LAGUNA HONDA HOSPITAL REPLACEMENT

FINAL ENVIRONMENTAL IMPACT REPORT FILE NO. 2000.005E STATE CLEARINGHOUSE NO.2001022015

SUMMARY OF COMMENTS AND RESPONSES
PUBLICATION DATE: JUNE 17, 2002

FIGURE 2.0-4

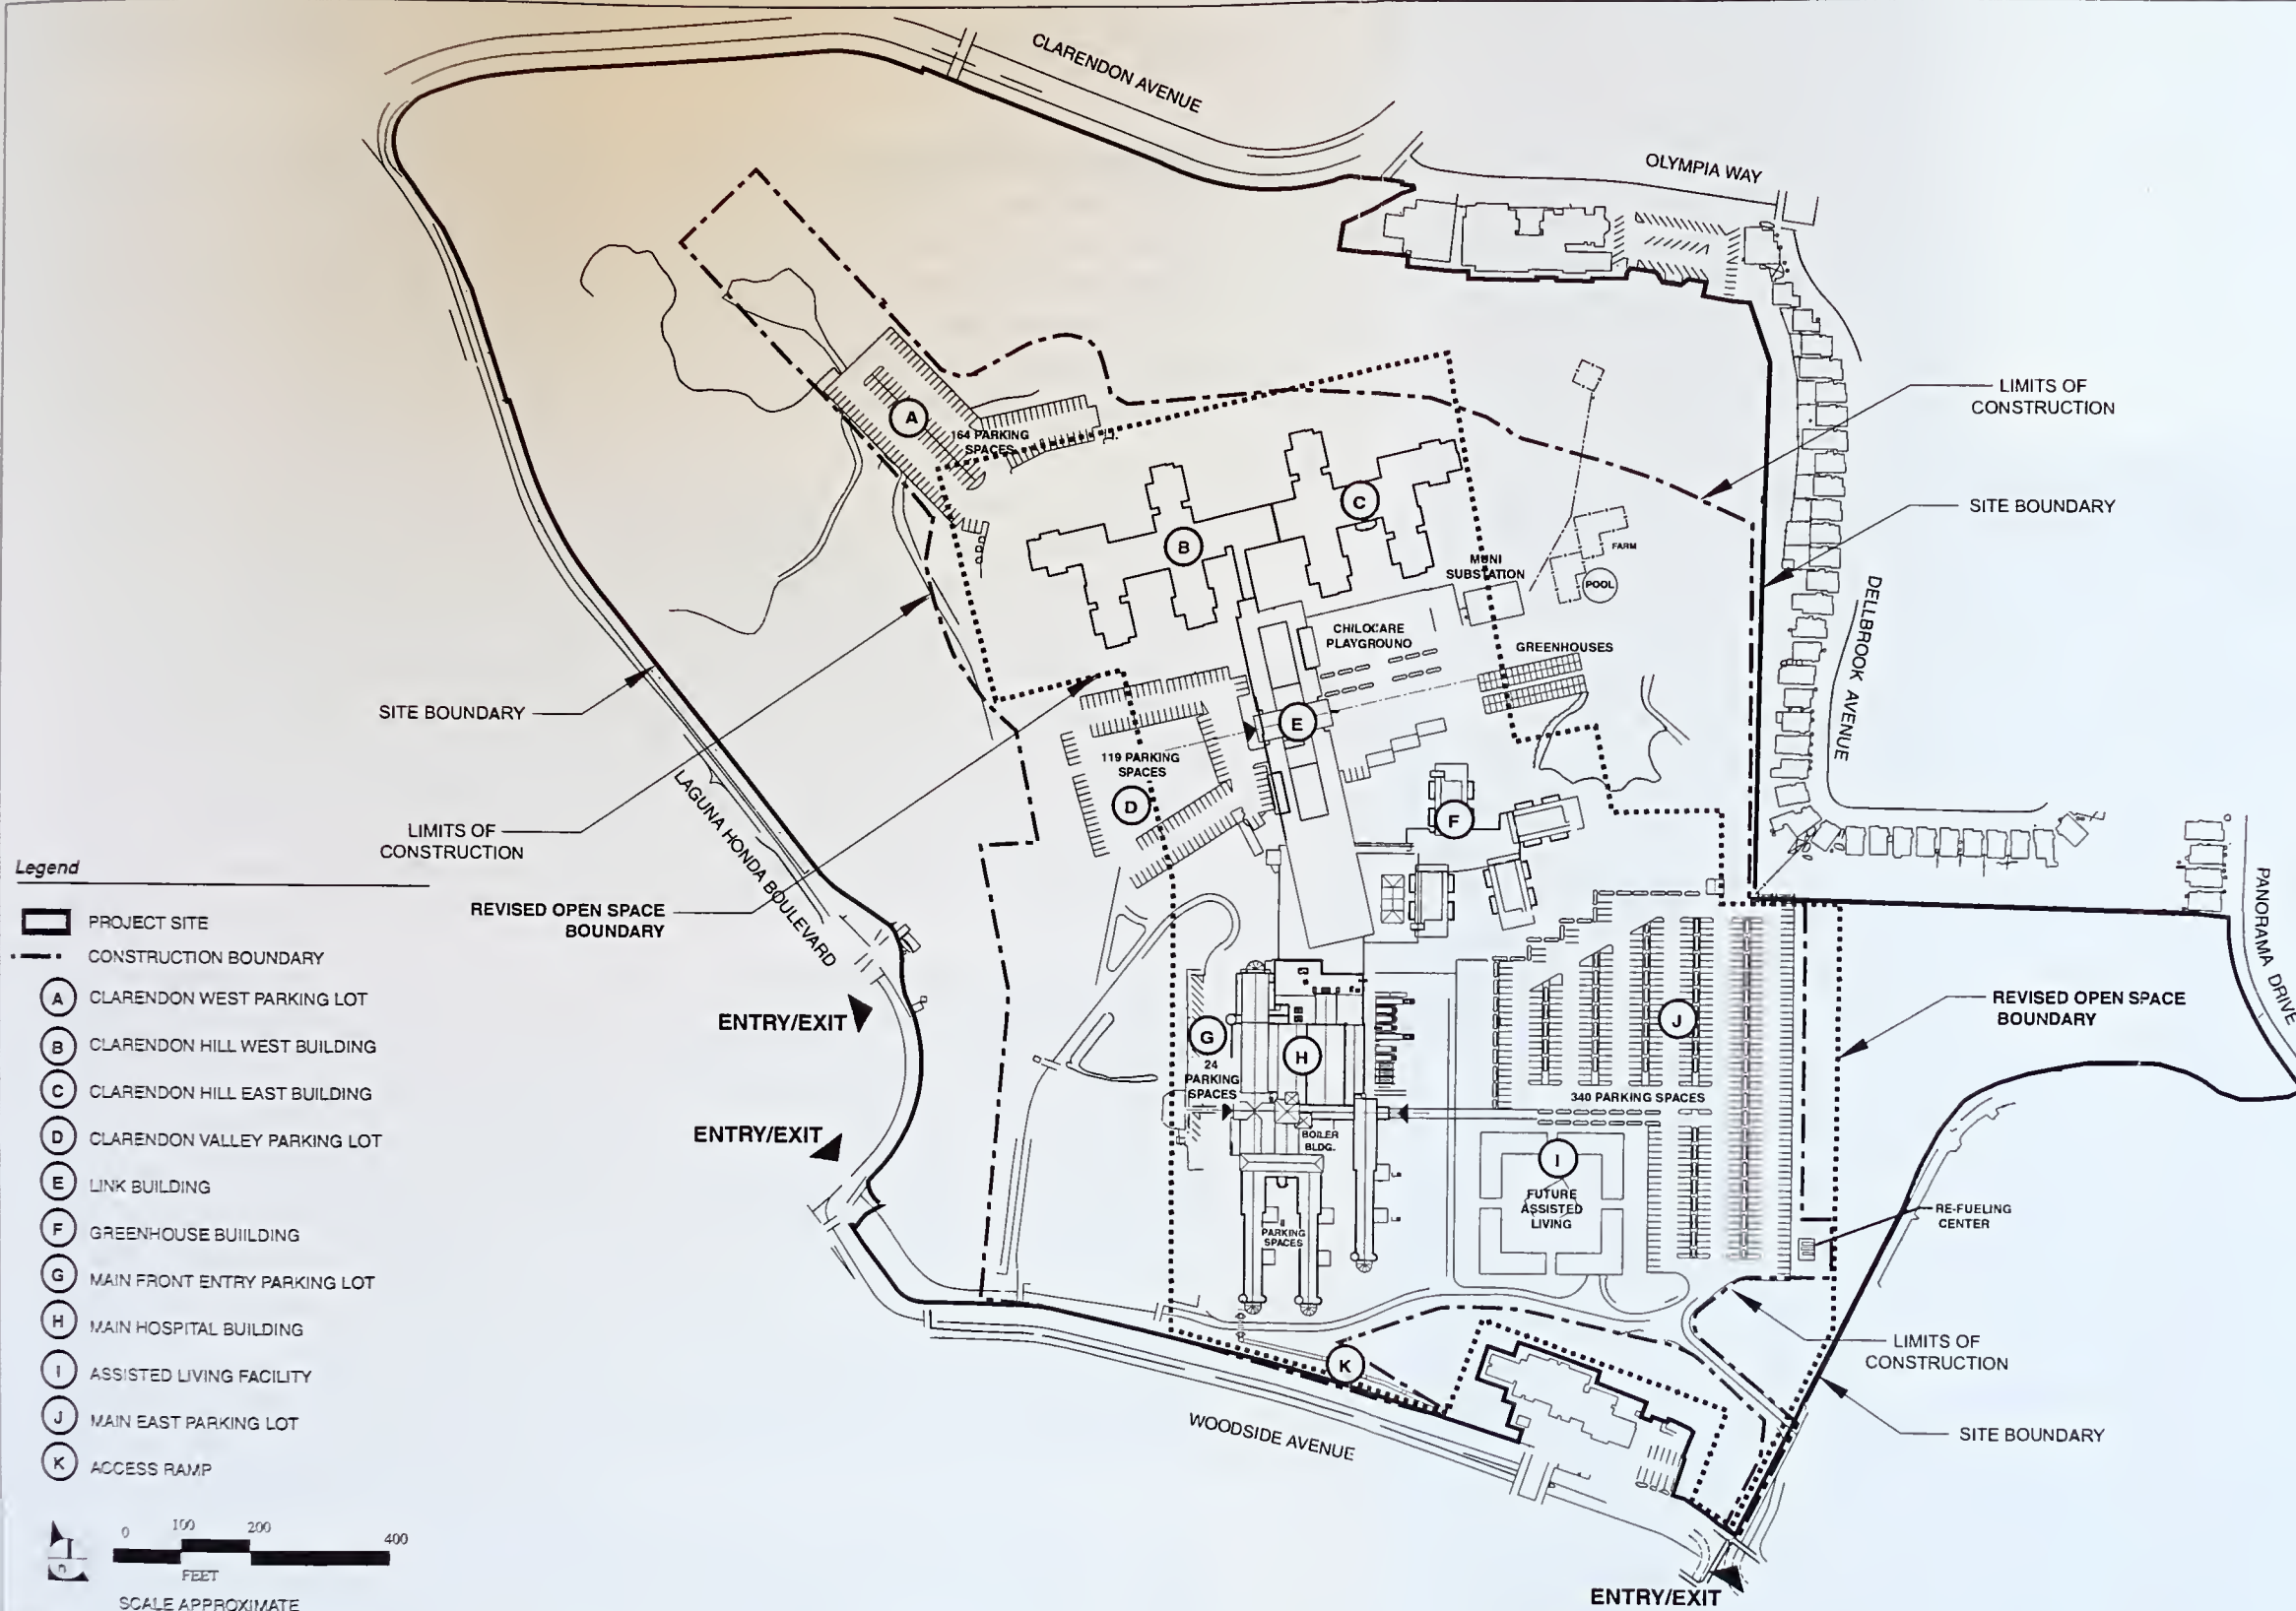
The location of the proposed re-fueling center shown on **Figure 2.0-4, Proposed Site Plan**, of the Draft EIR is incorrect. As shown on **Figure 2.0-4, Proposed Site Plan (Revised)**, the re-fueling center would be located on the southeast corner of the Main East Parking Lot, approximately 500 feet from the property line of the nearest Dellbrook residents. The relocated re-fueling center would be about 200 feet further from the Dellbrook residents' property lines than the existing re-fueling station.

"The Proposed Site Plan (**Figure 2.0-4**, p. 2.0-13) shows, at the (south) eastern panhandle of the site, a northerly bulge extending into the private properties of #s 1154, 160, and 166 Dellbrook Avenue, and #s 201 through 227 Panorama Drive. Unless such a transfer to properties has taken place or is planned, this apparent drafting error needs to be corrected." **Gilbert De La Mora, et al.**

Figure 2.0-4 is hereby revised to show an access ramp from Woodside Avenue to the main entrance of the Main Hospital Building (see Figure 2.0-4, Proposed Site Plan [Revised]).

Figure 2.0-4 has been refined to include the revised open space boundary that would occur as a result of the project. As explained in the Draft EIR, the existing open space boundary, has not been clearly defined and is presented in the Draft EIR as an approximation. For this reason, a quantitative analysis can not be conducted to determine the changes in the open space boundary from implementation of the proposed project. However, given the approximate existing open space boundary and the proposed revised open space boundary it is clear that the open space boundary would not substantially change. Therefore, it is safe to assume that over 50 percent of the site area would remain in permanent open space. The Planning Department has recently determined that the project no longer requires a *General Plan* Amendment since only a minor adjustment would occur to the open space boundary and the general configuration would not change. Please refer to Section 5.0, Staff-Initiated Changes to the Draft EIR for a discussion on the removal of the General Plan amendment from the Draft EIR text.

The project site boundary as shown on **Figure 2.0-4** is incorrect in the area noted by the commentor. As shown, the project boundary on the eastern portion of the campus should not extend to the north into the residential homes on Dellbrook Avenue. Please refer to **Figure 2.0-4 (Revised)** to view the correct project site boundaries.

FIGURE 6.0-1

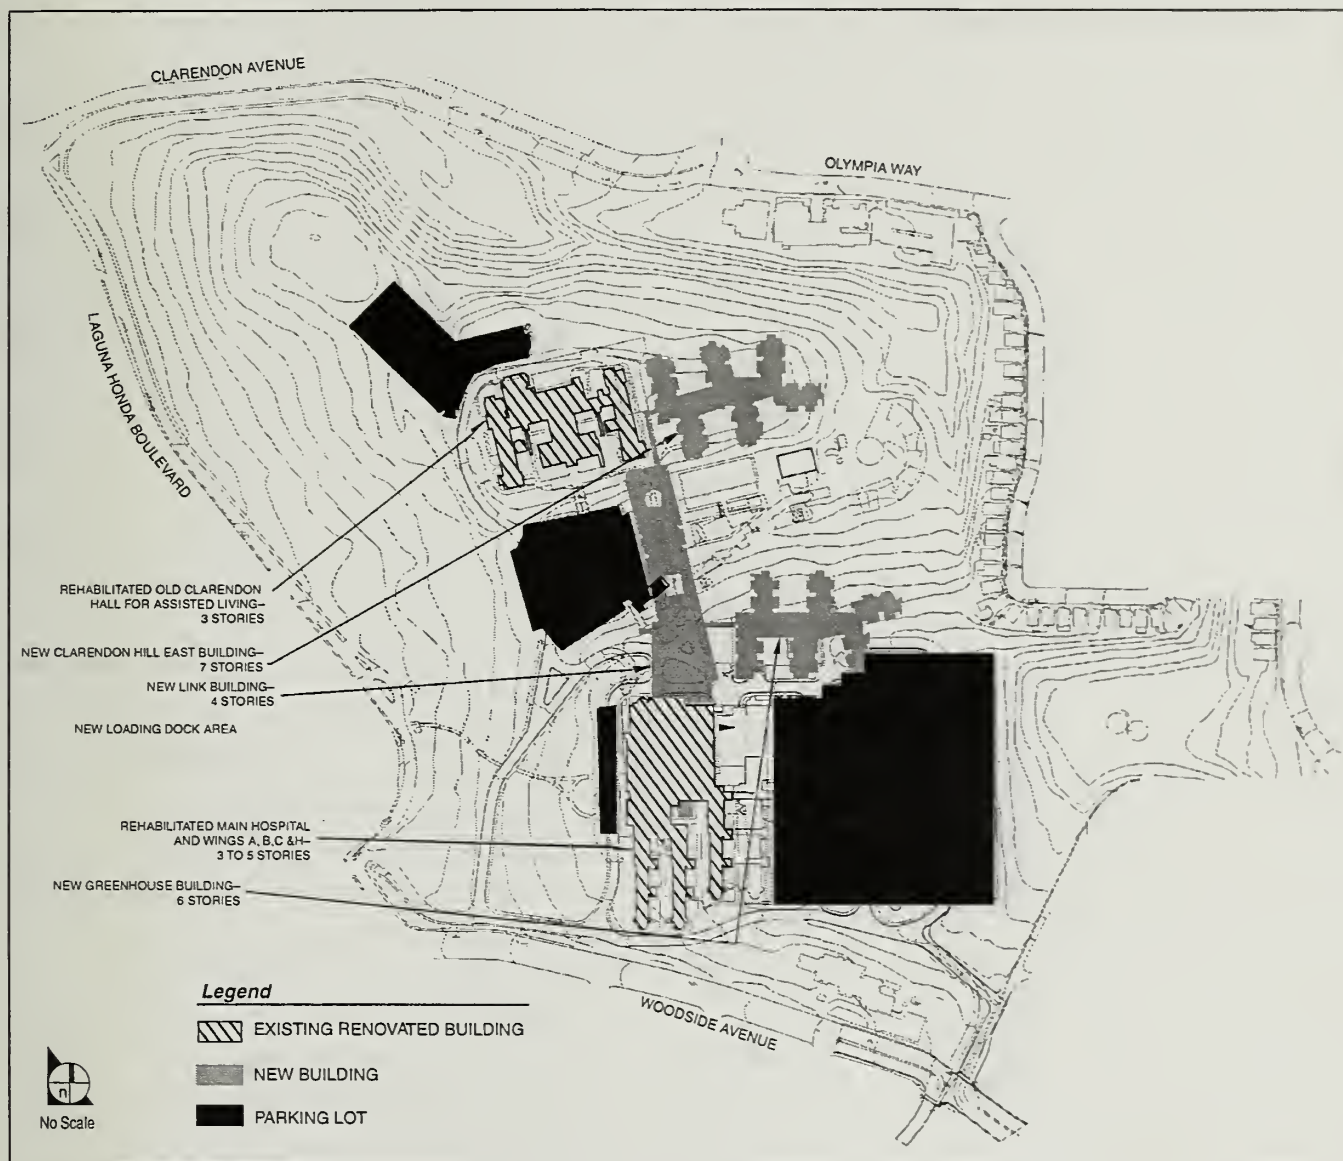
Laguna Honda Hospitals 'open space' should not be decreased for a non-essential facility such as the satellite dish complex. As can be seen on **Figure 2.0-4**, the proposed site plan, the satellite dish complex will compromise approximately 3 - 4% of the projects existing open space. The reduction of Laguna

In addition, **Figures 6.0-1, Alternative One: Site Plan and 6.0-2, Alternative Two: Site Plan** have been revised to removed the satellite dish complex from the graphics since the satellite dish complex would no longer exist on the hospital campus.
